Access Compliance Report Public Rights-of-Way (Curb Ramps)

Main Street: DEAN_ST Cross Street: RAINBOW_DR Location: SE

ADA ID: RPRK211014152850 Ramp Type: Type 1 - Perpendicular Diagonal Initial Pass/Fail: Fail Overall Compliance: No Severity Score: 16

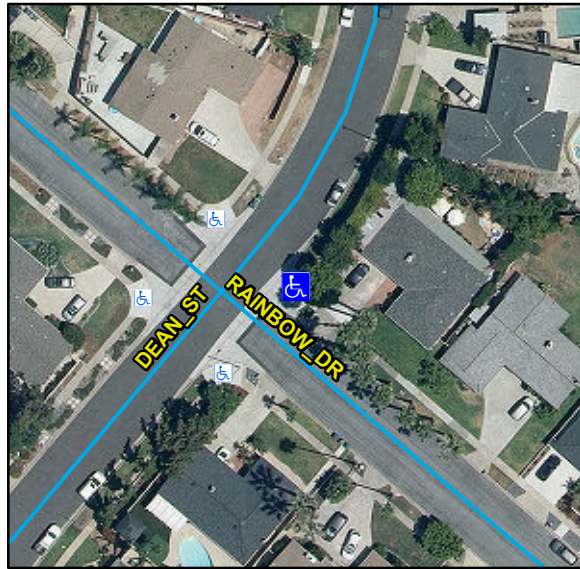
R304.2.2, R304.5.3, STD 1115

Remove & Replace Curb Ramp With Two New Directional Ramps or Equivalent.
